ADDENDUM NO. 2**NEW PRIMARY UNDERGROUND SERVICE
AND SWITCHGEAR REPLACEMENT
FOR THE MEADOWS COTTAGE COMPLEX
AT THE GOVERNOR BACON HEALTH CENTER
DHSS/OMB/DFM CONTRACT NO.: MC3505000016****FE&ES COMM. NO.: 09-1011**

- 1.0 This Addendum No. 2, dated July 6, 2011, shall be made part of the Project Manual and Drawings dated June 6, 2011, for the New Underground Electrical Service at the Meadows Cottage Complex, Governor Bacon Health Center, Delaware City, DE.

SK-E6

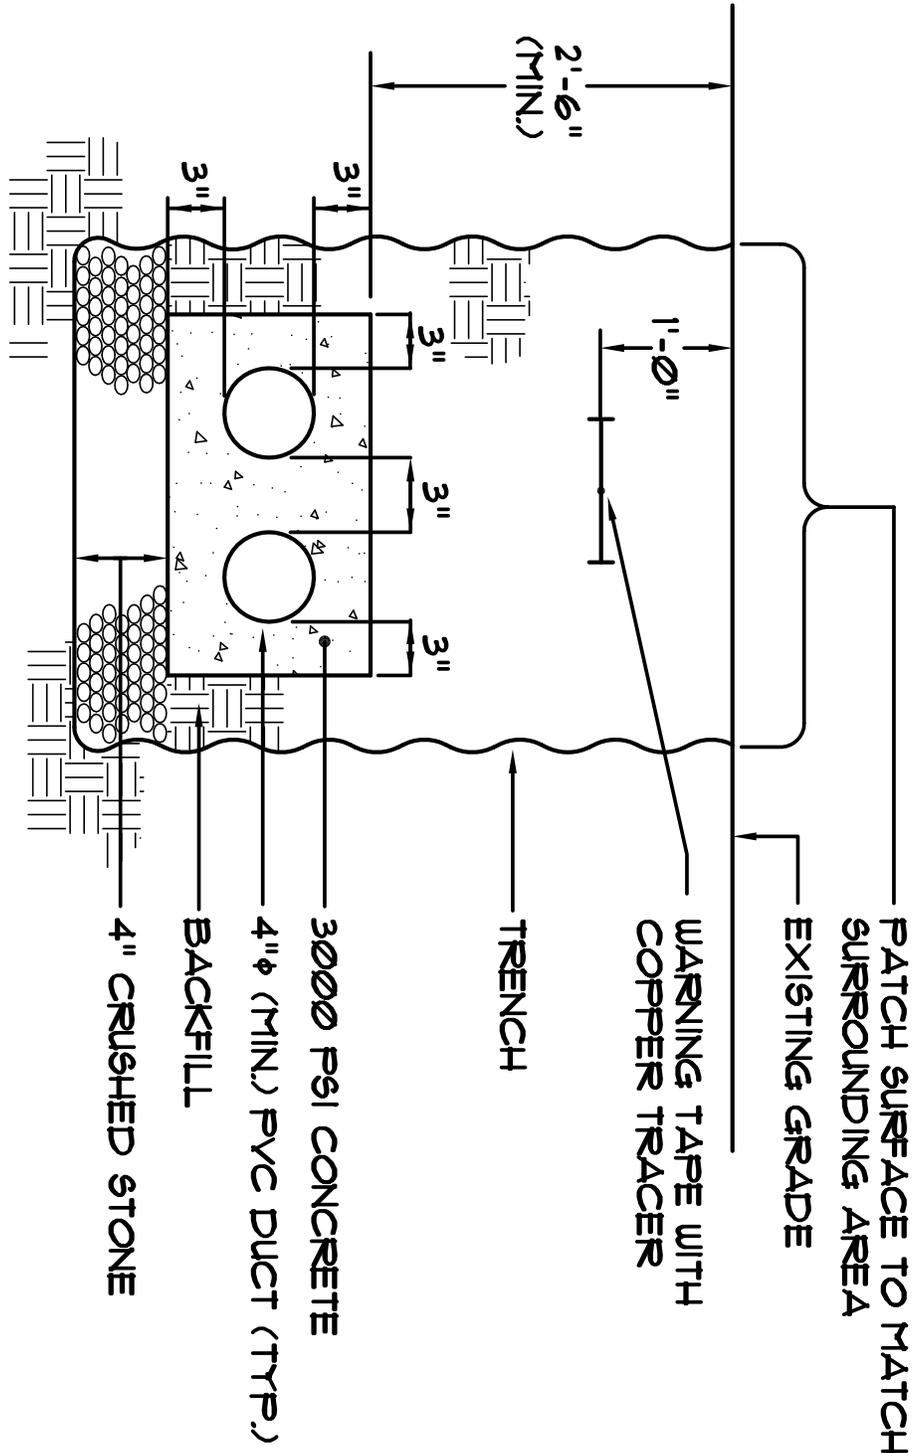
- A. Drawing E-5: Single line diagram: Identify that the main (Gateway) building is supported by a Kohler 350KW emergency generator.
- B. Drawing E-6: Add sketch SK-E6 for ductbank detail under Alternate No.’s 2 and 2A.

TWO-WAY HIGH VOLTAGE DUCTBANK DETAIL
